Grand Teton National Park

Bicycle Road Safety Audit

Gros Ventre Junction- US Highway 26/89/191

November 30, 2012

Figure 9. Concept Diagram: New Grade Separated and Relocated At-Grade Pathway Crossings.

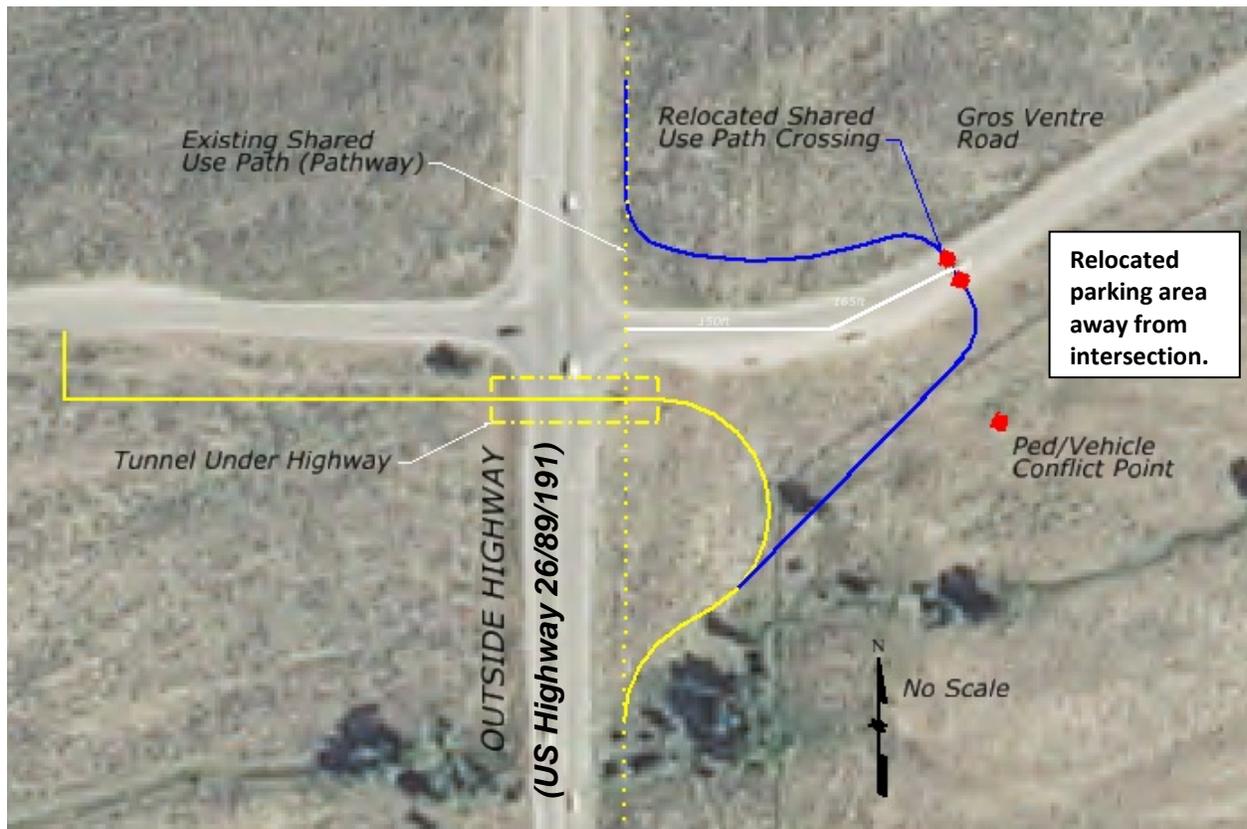
Relocate the existing at grade crossing of the Gros Ventre Road crossing further east, providing a better angle to see on-coming traffic and to improve driver visibility of pathway users. See Concept Drawing #2 in Appendix A.

There are three options for grade separated path crossings. The first one is to construct a grade separated shared use path crossing (underpass) under the highway to reduce the potential for conflicts with vehicles on the highway. See Concept Drawing #1 in Appendix A.

In the second concept, shown in Figure 9, the existing at grade crossing of the Gros Ventre Road would be relocated farther east of the intersection. The new at grade crossing location would reduce the number of pathway-vehicle conflicts in the intersection, provide additional time for drivers to recognize and respond to the pathway crossing before approaching the intersection or after turning onto Gros Ventre Road, and would provide stacking space for vehicles after the crossing so the crossing is not blocked by vehicles waiting at the intersection. There is an example of an at-grade shared use path crossing in the park near the Taggart Lake Trailhead on the Teton Park Road. A grade separated crossing of the highway would be very similar to that proposed in Concept #1.

Figure 11. Concept Diagram: Two At-Grade Pathway Crossings Integrated Into a Modern Roundabout with Conflict Points.

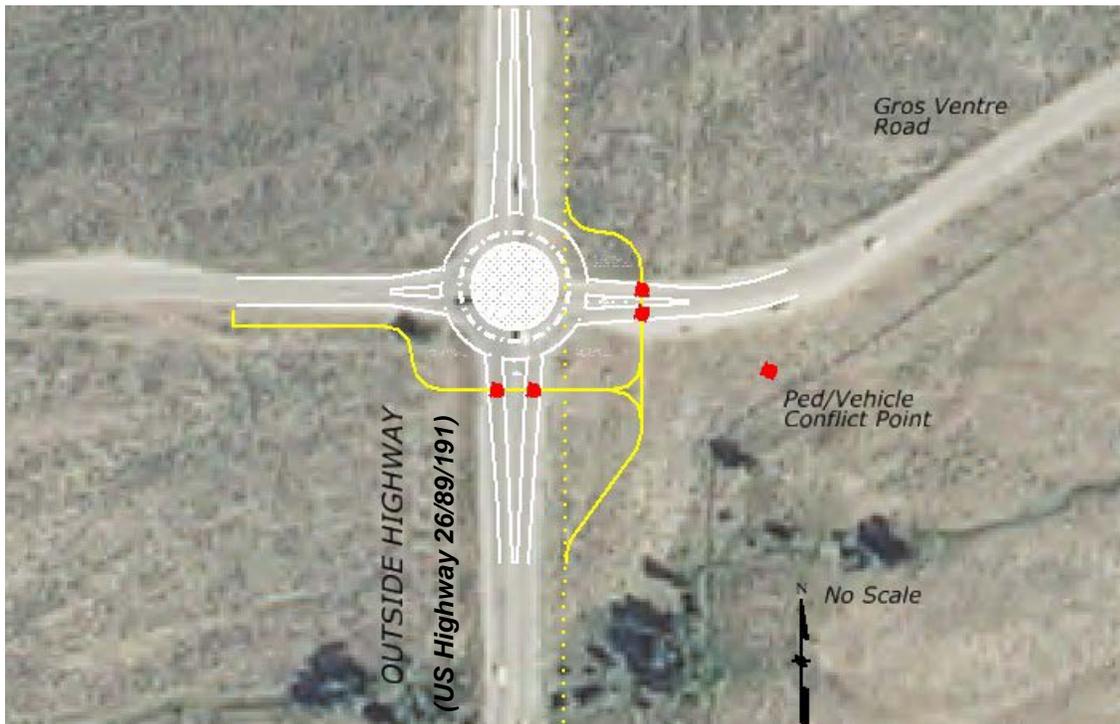
Construct two new at grade shared use path crossings surrounding a modern roundabout. The roundabout would provide multiple benefits; provide an intersection with less conflict points and would also allow for cyclists to cross one lane at a time with a splitter island serving as a median refuge. See Concept Drawing #3 in Appendix A.

The existing intersection presents 16 pathway user- vehicle conflict points. A modern roundabout concept presents four, as shown in Figure 11. The refuge area within the splitter islands allows users to cross one lane of traffic at a time and would be large enough to handle bikes towing trailers and groups crossing together. These pathway user crossing points are set back from the intersection improving visibility. The slower speed of the vehicles moving through the roundabout (approximately 20 MPH) reduces the severity of the conflicts (compared with vehicles travelling at the currently posted speed of 45 MPH).

Figure 11 shows the approximate roundabout footprint with crossings for pathway users.
